Iowa Department of Transportation

MINUTES OF IOWA DOT SPECIFICATION COMMITTEE MEETING

March 13, 2014

MODIFIED STANDARD ROAD PLAN	REVISION	
	2	XXXXX
	RR-27	
SHEET 1 of 1

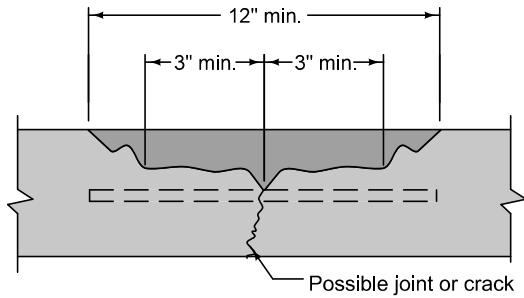
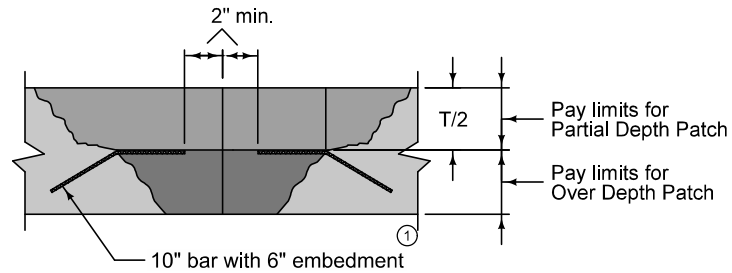
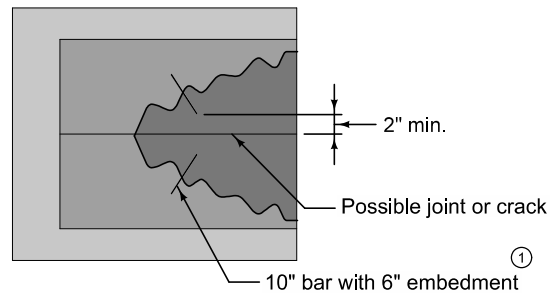
MODIFICATIONS: Changed 10" dimension to 12" and added additional patch on the Possible Patch Locations.
